ADDENDUM NO. 1

Date: August 22, 2025
Project: **Phase 2: Foundation Installation (Multipurpose Laboratory Building)**
Job No.: 24600-01

PROJECT TITLE
**LAS GALLINAS VALLEY
SANITARY DISTRICT
LGVSD -
MULTIPURPOSE
BUILDING**

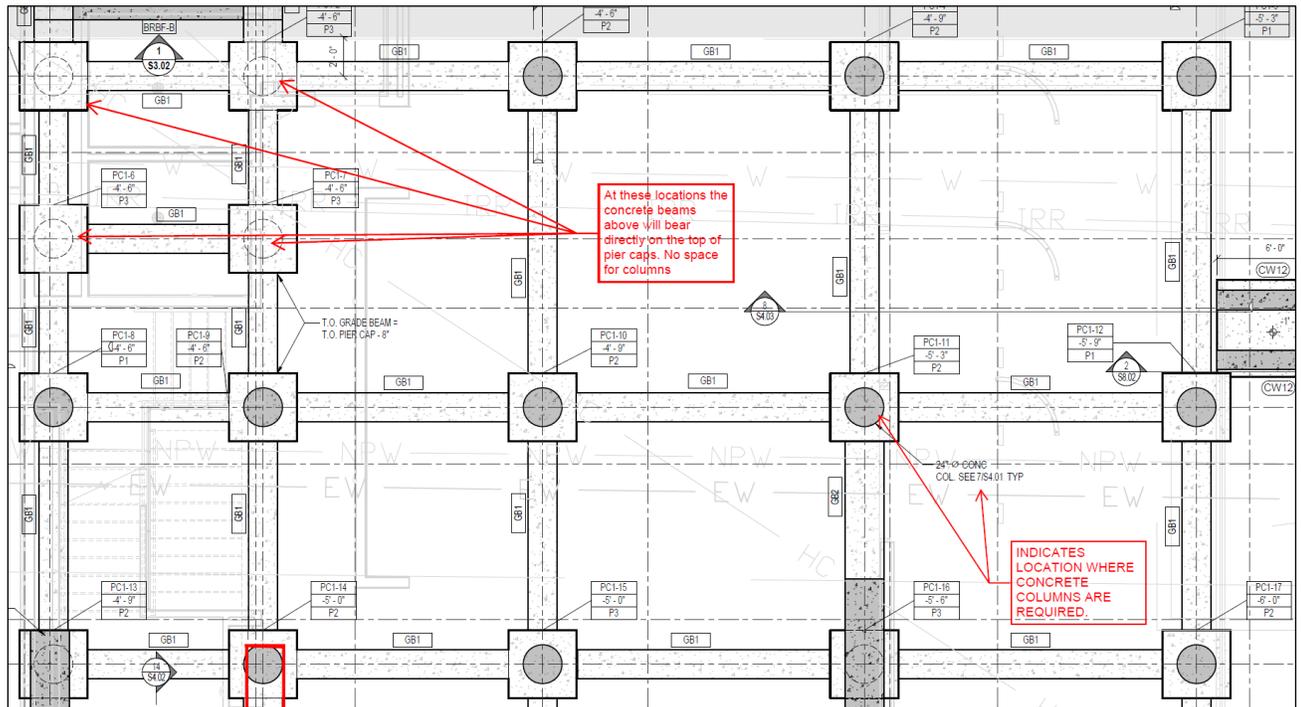
Q14. What pier caps will have Piles on top, per detail 7/S4.01?

Response: See red markups below from the Project structural engineer for partial location of concrete columns on top of the pier caps. See Drawing Sheet S2.00F for the Foundation Plan.

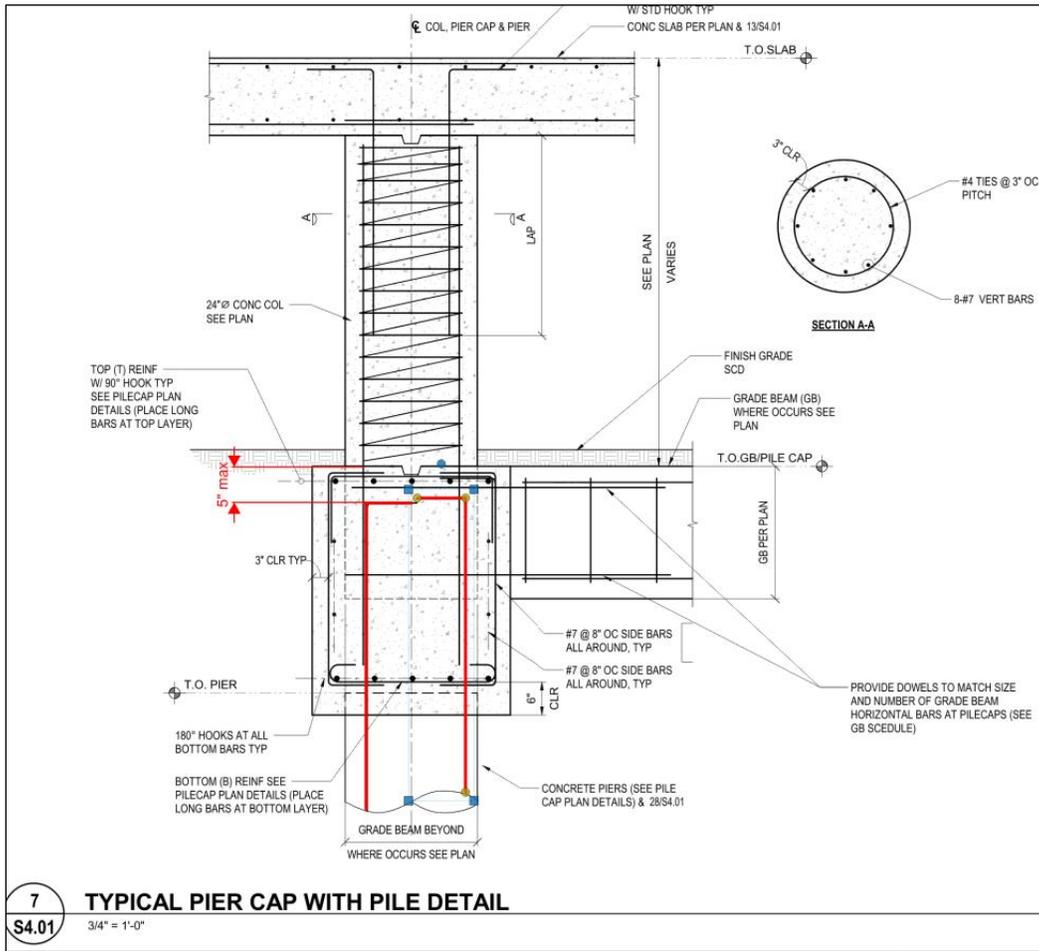
Q15. How far is dowel required to protrude into the upper pier in detail 7/S4.01?

Response: The drilled pier vertical reinforcing shall extend all the way to the top of the pier cap at a maximum of 5" below the top of the pier cap as shown in red markup below from the Project structural engineer. The column dowels shall match the size and spacing of column vertical reinforcing and extend down to the pier cap at least 42".

S2.00F

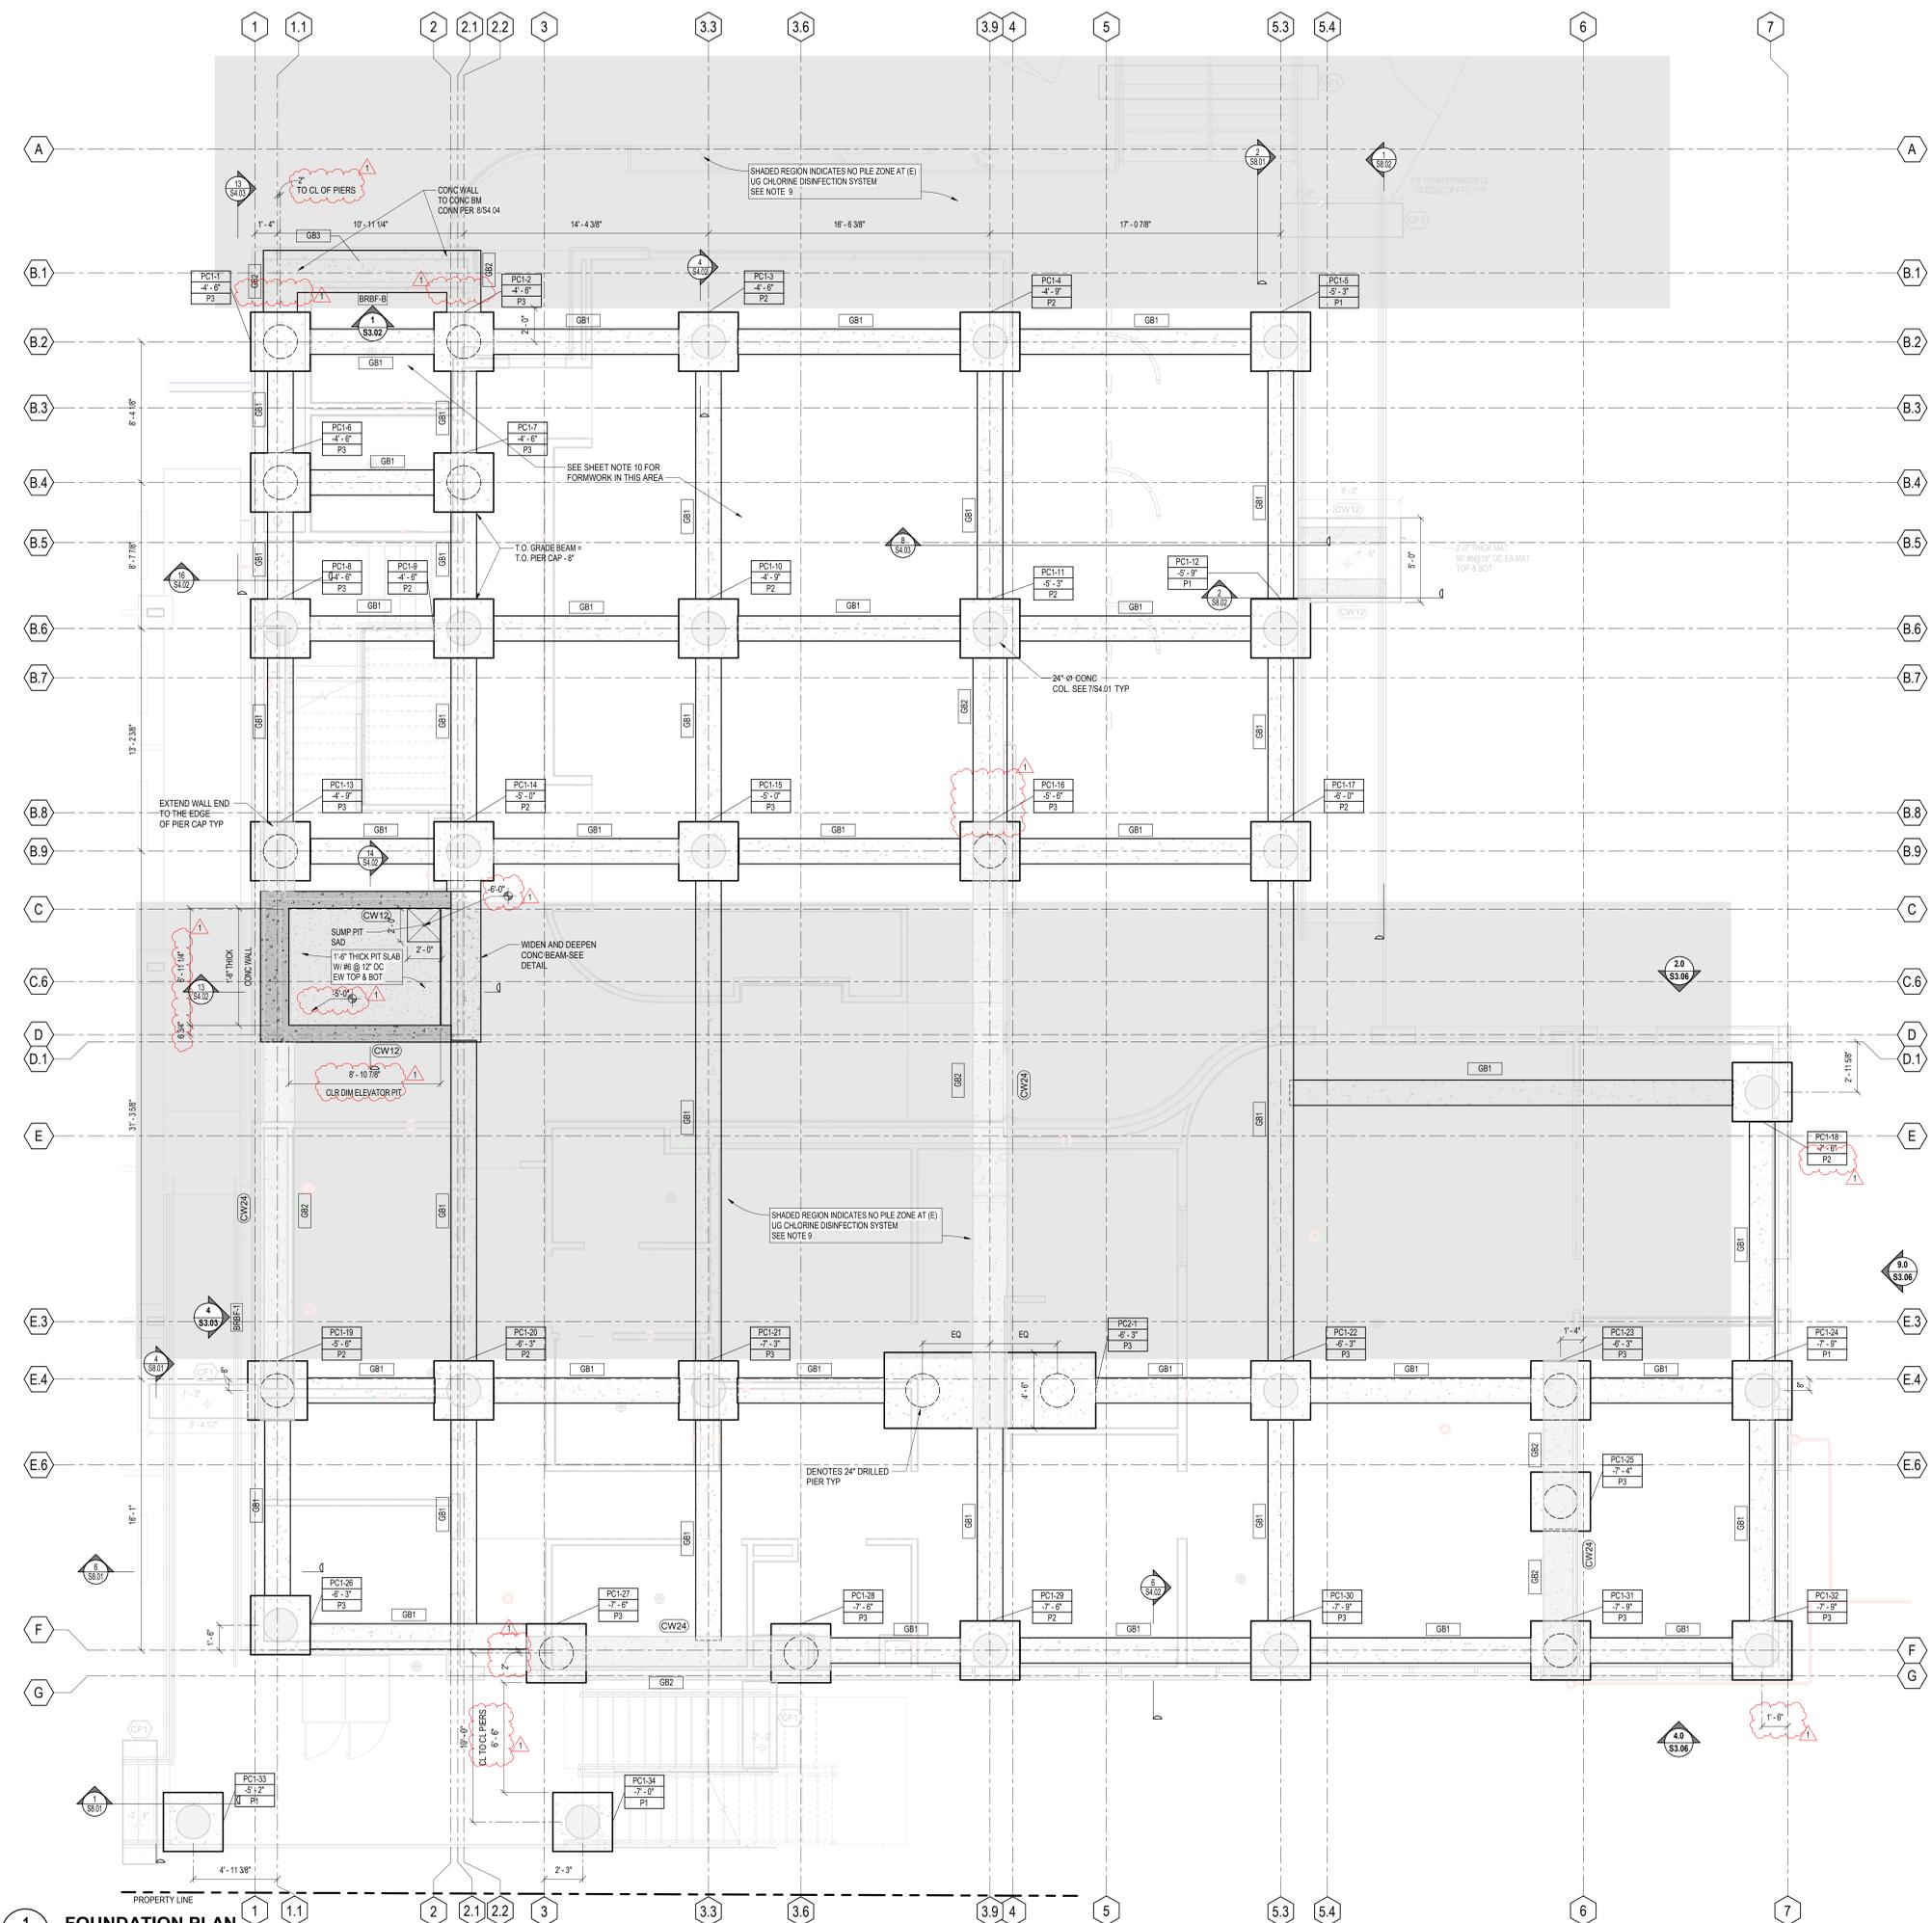
Q17. Plan Sheet S2.00F: At A-line, two cuts reference pages S8.01 and S8.02. No such pages exist. Please provide.
Response: Disregard drawing reference callout; Sections are for the upcoming Phase 3 project.

Q18. Plan Sheet S2.00F: At G-line, there is an elevation on page S3.06. No such page exists. Please provide.
Response: Disregard drawing callout. Elevation is for scope above pier cap at first and second floor.

- Q24. Plan Sheet S2.00F: Per note 9, please confirm the maximum weight of the equipment that can pass over the existing tanks.
Response: See response to Q8 above.

Load Distribution Chart for Applied Surface Loads

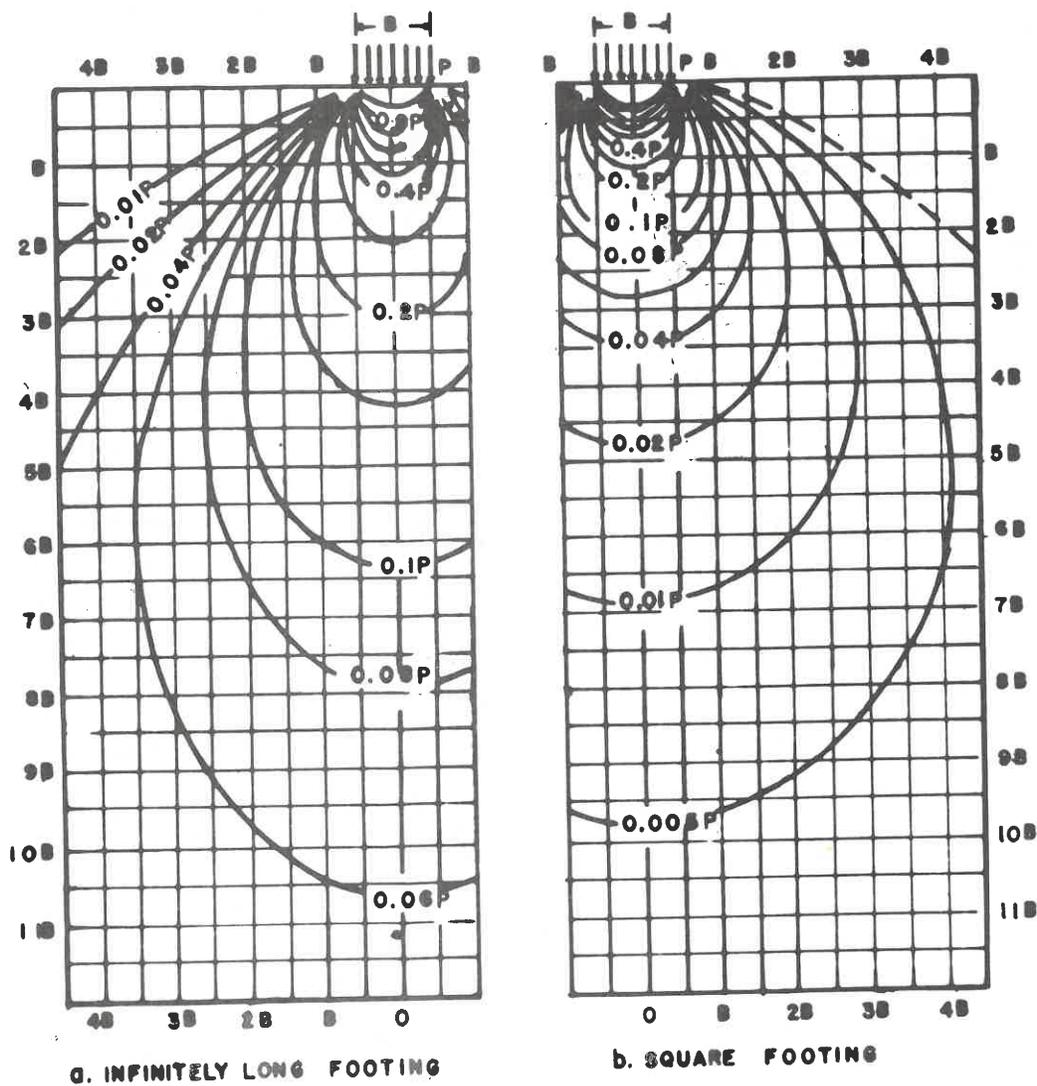
- e. For loading calculations, see Attachment B for load distribution chart for applied surface loads provided by the Project geotechnical engineer. For track-mounted equipment, use the infinitely long footing chart (figure a.). For wheel loads, use the square footing chart (figure b.). Assume that “B” is the width of the track or wheel and “P” is the applied surface load.
